Subject: Duke Energy Corporation
Oconee Nuclear Station - Units 1, 2, and 3
Docket Nos. 50-269, 50-270, and 50-287

Revisions to Topical Report DPC-NE-3003 In Support of
Steam Generator Replacement
Response to NRC Staff Request for Additional
Information

Duke Power Response To Request For Additional Information

DPC-NE-3003 Revision 1 “Mass and Energy Release and Containment Response Methodology”

(14.1 ft² Break - SG Inlet - High Initial RCS Flow w/ M3 Pump Degradation Model)

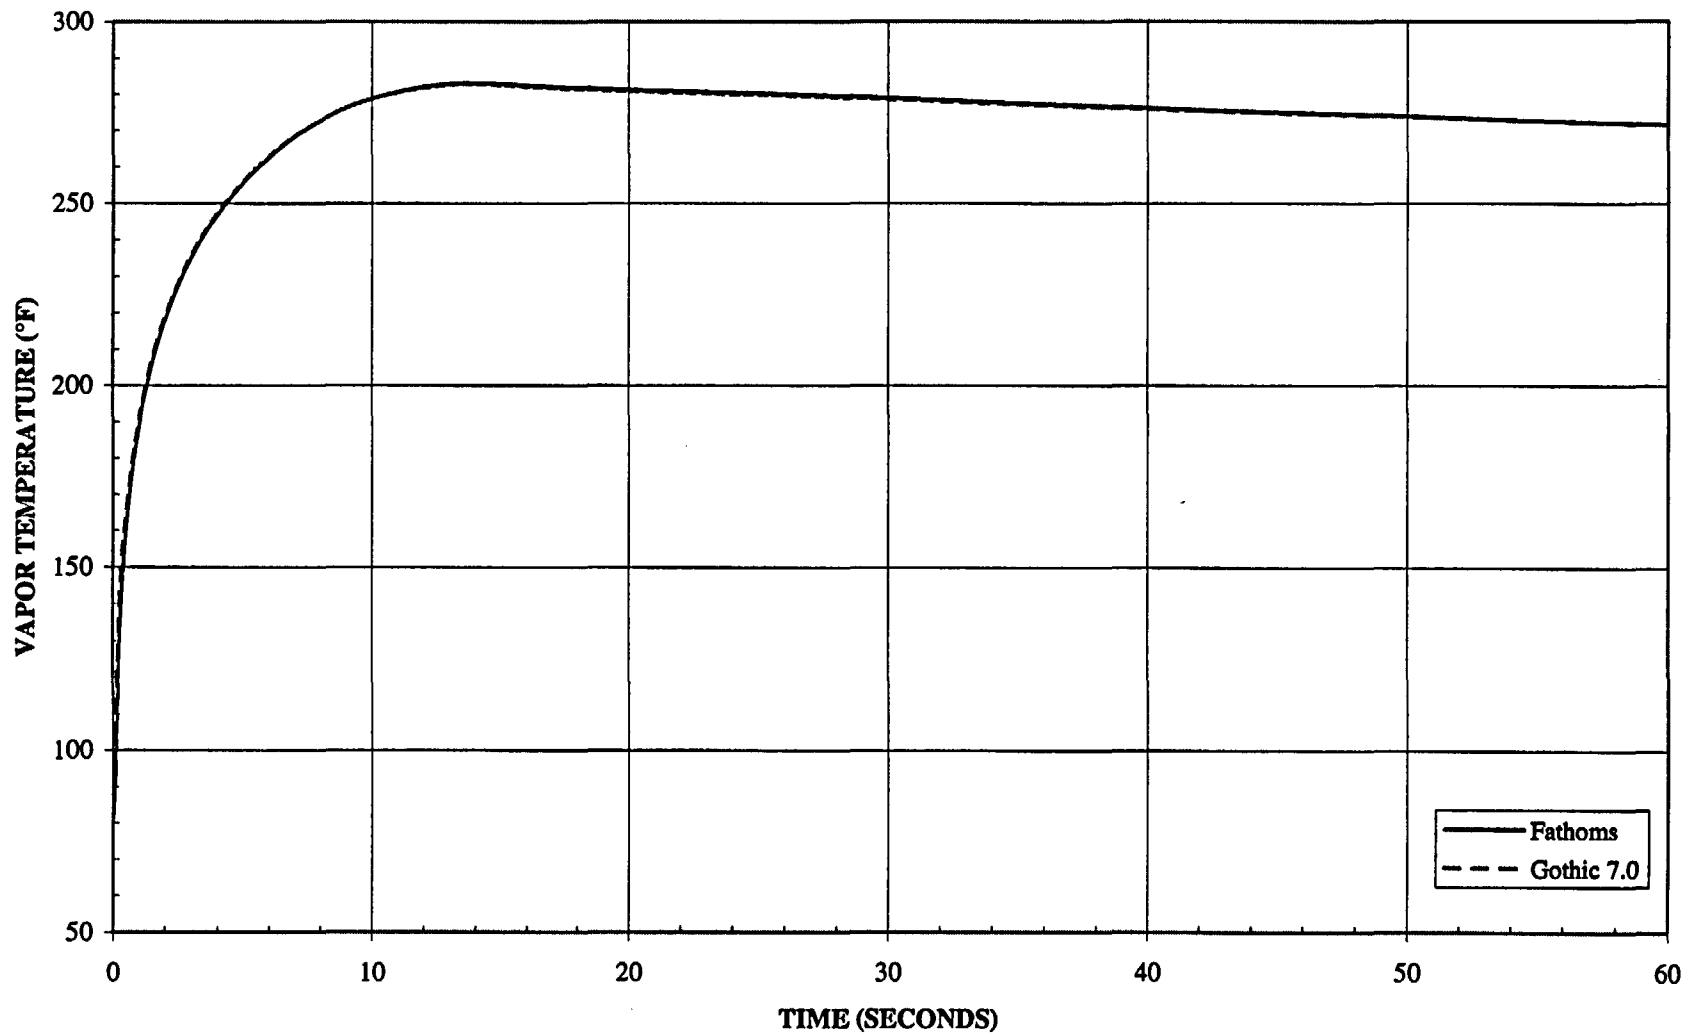
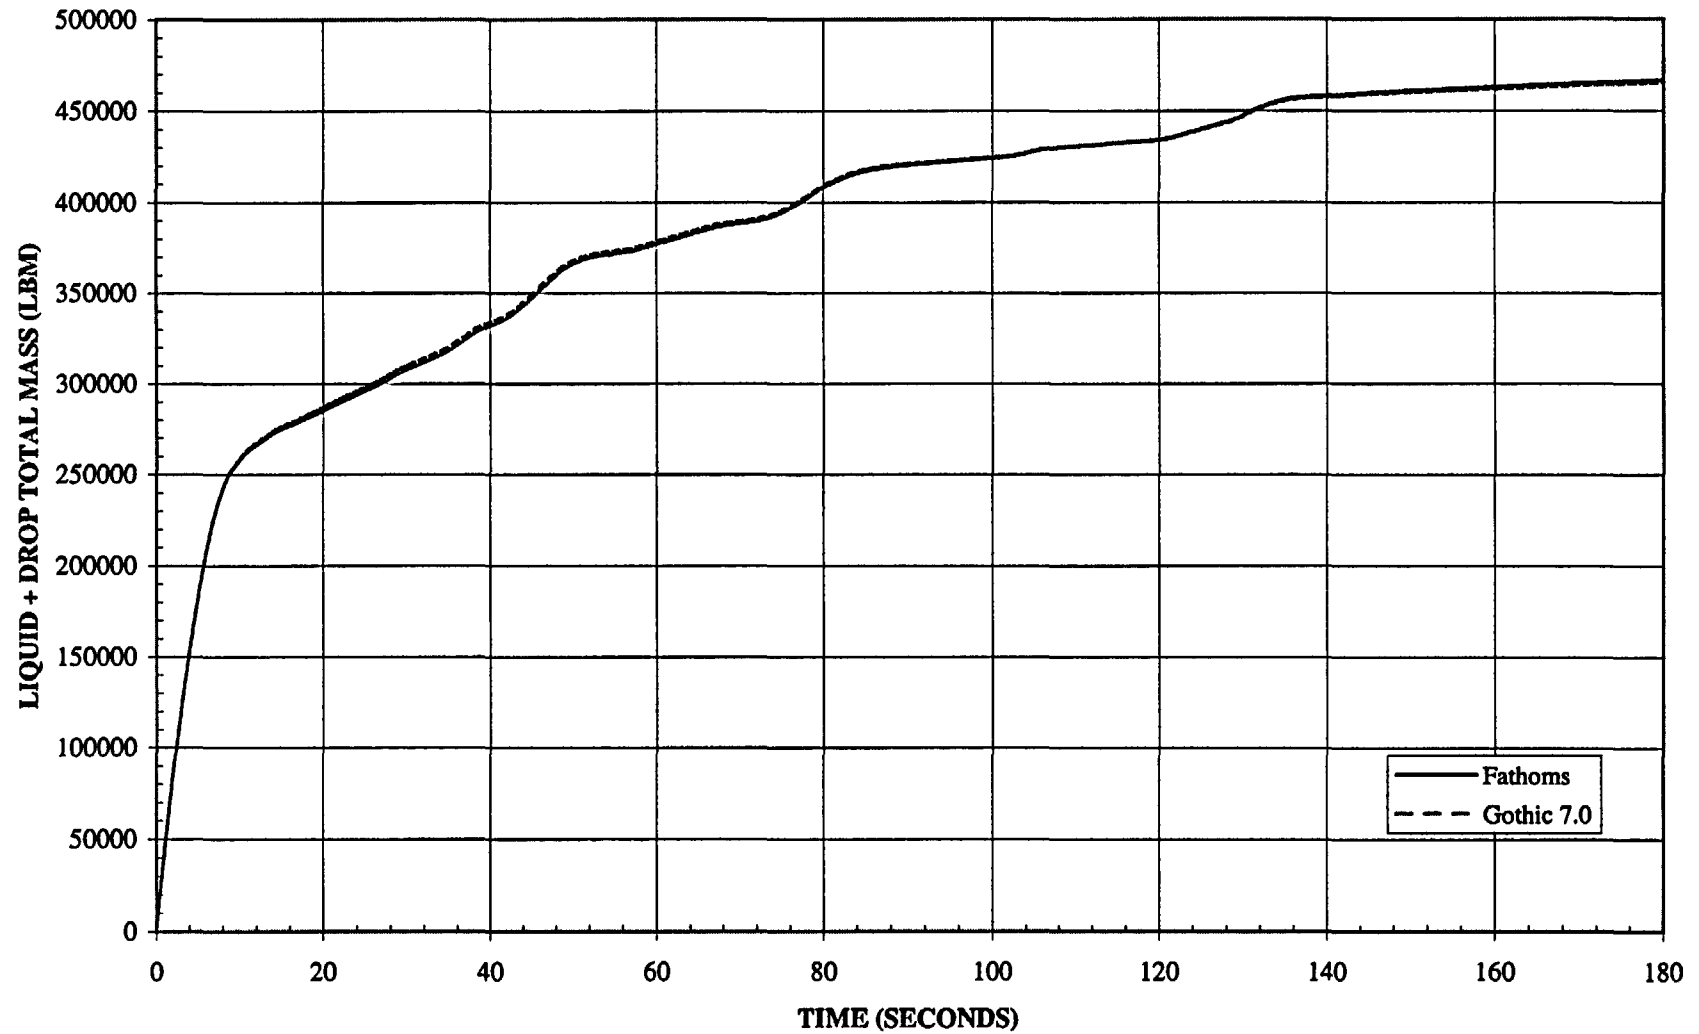
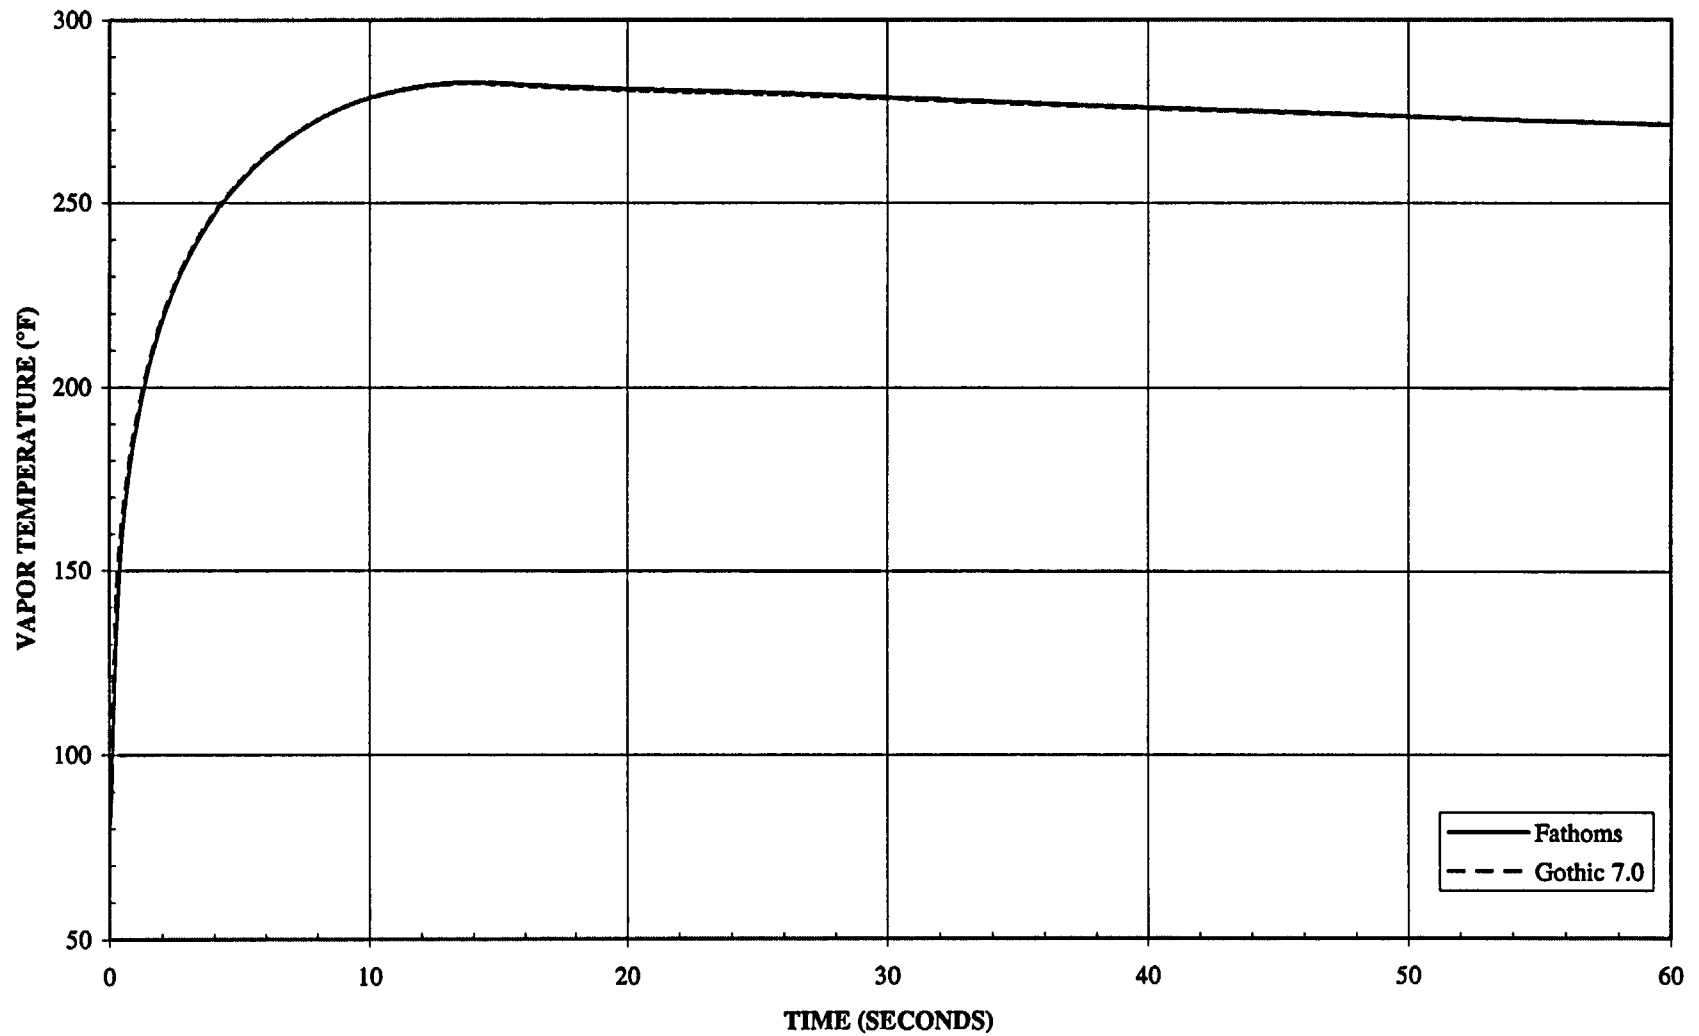
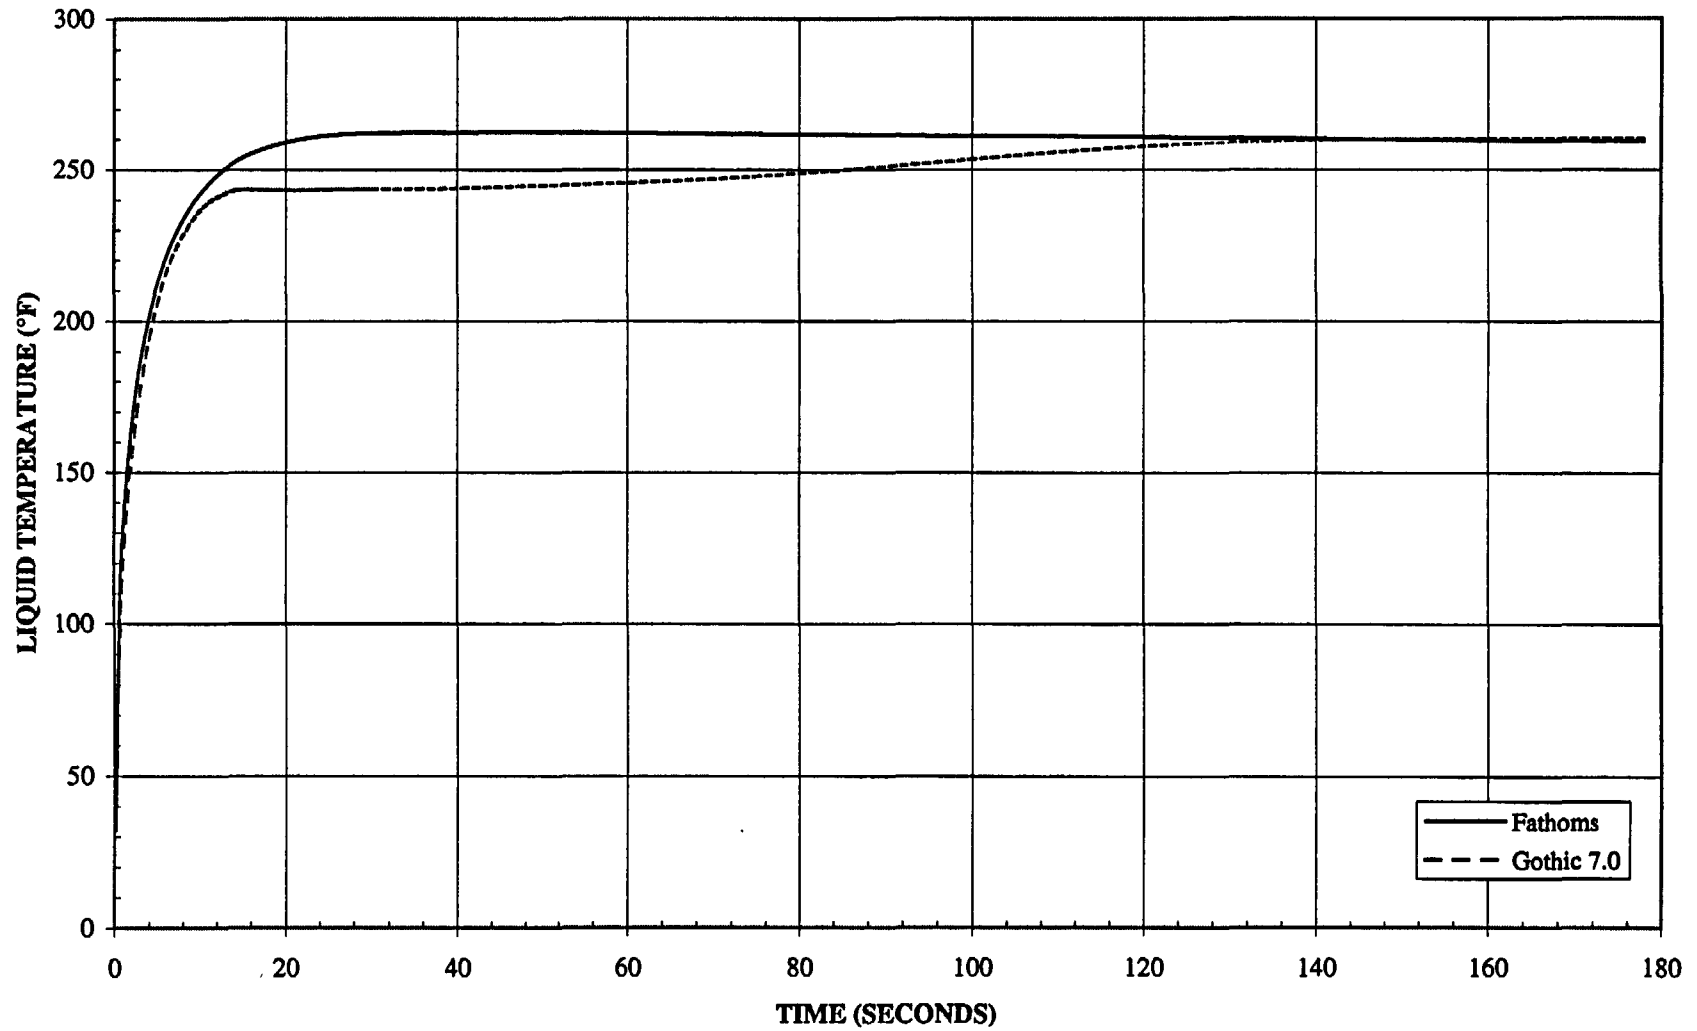
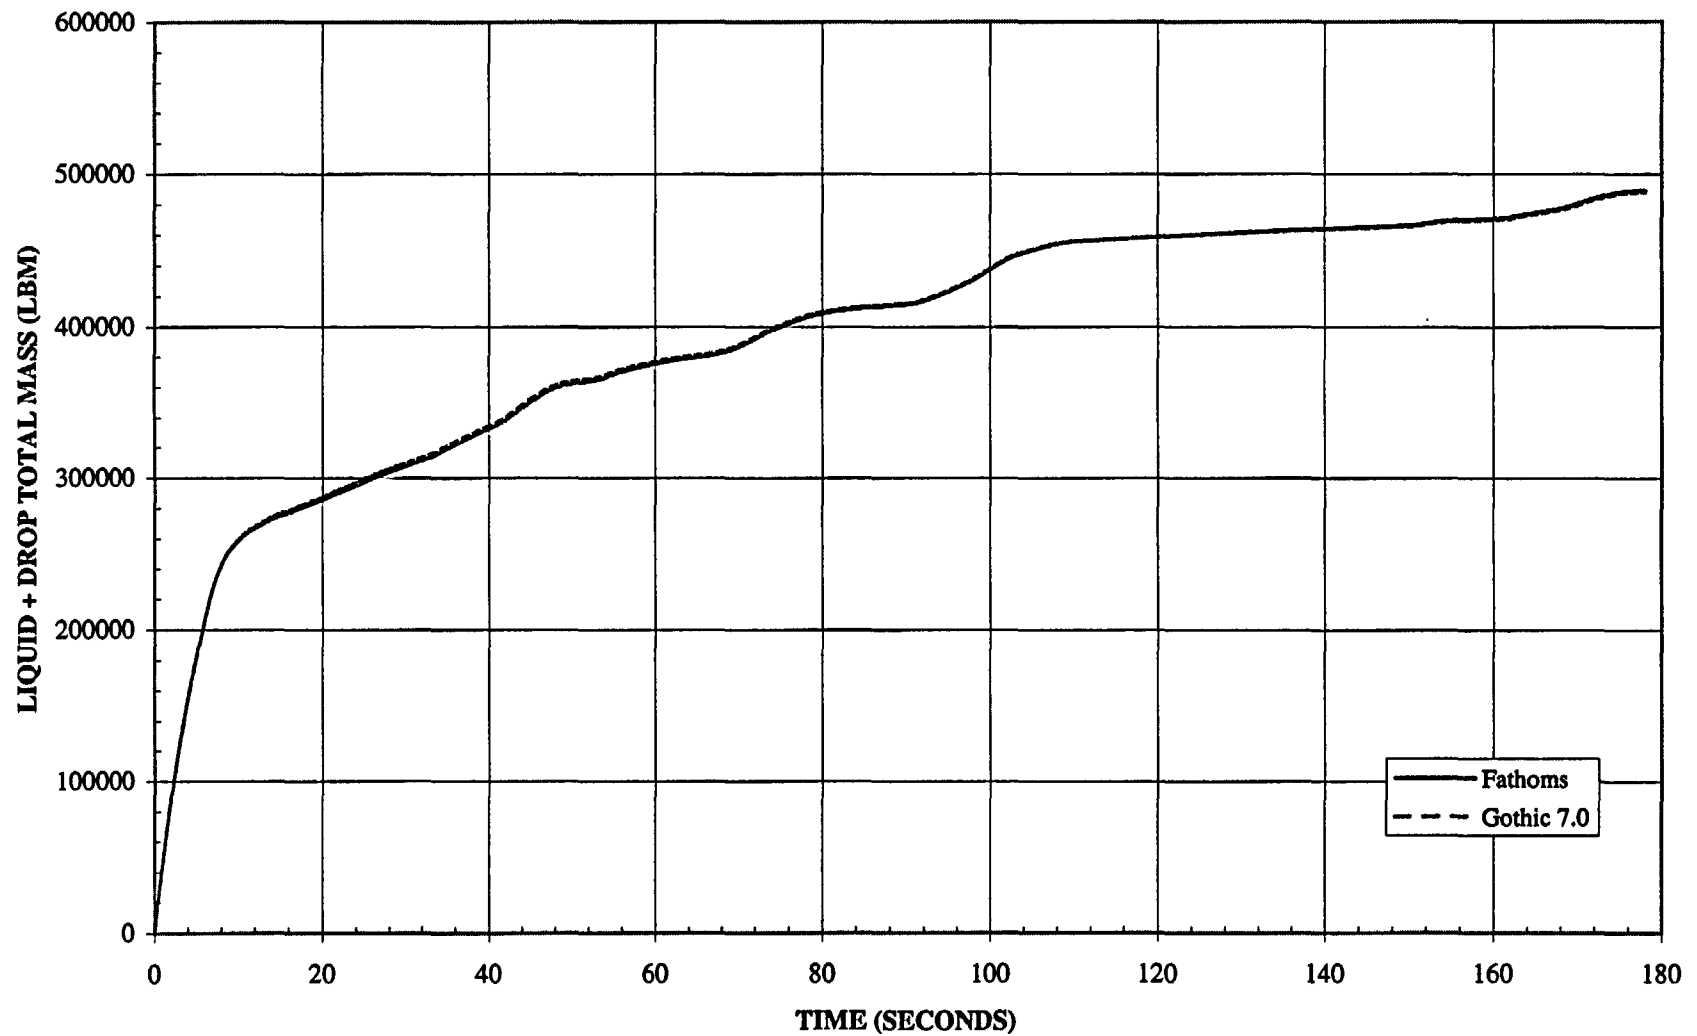
3. Please provide the results using the GOTHIC 7.0 code of peak pressure and temperature calculations for the sensitivity cases listed in Table 3.1-1 of DPC-NE-3003 in tabular and graphical form. If the results or conclusions are significantly different from those presented in DPC-NE-3003P, explain the difference.

Response: Table 3.1-1 of DPC-NE-3003 describes a spectrum of LOCA peak pressure cases including a range of break locations and sensitivity analyses for several important modeling assumptions. The staff's request is understood to focus on the difference in the predicted results from the FATHOMS and GOTHIC 7.0 code versions. Rather than show the comparison for the cases in Table 3.1-1, a different set of cases has been selected which is more focused on the current knowledge of the key sensitivity parameters. Also, the results presented are for the ROTSGs, which is the subject of Revision 1 to the topical report.

The results of the 14 code comparison analyses are shown in Table 3-1 below and in the figures that follow. In general, the pressure and vapor temperature response predictions were very similar in both magnitude and trend. GOTHIC 7.0 predictions for peak pressures and vapor temperature were slightly lower (~0.5 psig and 0.5°F). These differences are consistent with the code model differences described in the response to Question #1. Both codes predict a saturated containment atmosphere due to the large amount of drops injected. The slightly lower pressure, vapor temperature, and liquid temperature from GOTHIC 7.0 may be attributed to additional drop hold up in the atmosphere. This effectively increases the heat capacity of the atmosphere and reduces the temperature rise for a given energy addition. A comparison of the total liquid and drop masses, and liquid temperatures, show the predictions of the two codes to be essentially the same. This is consistent with the changes in the drop deposition and entrainment models discussed in Question #1. These results show that the two code versions give essentially similar results for the same break location and initial and boundary conditions.
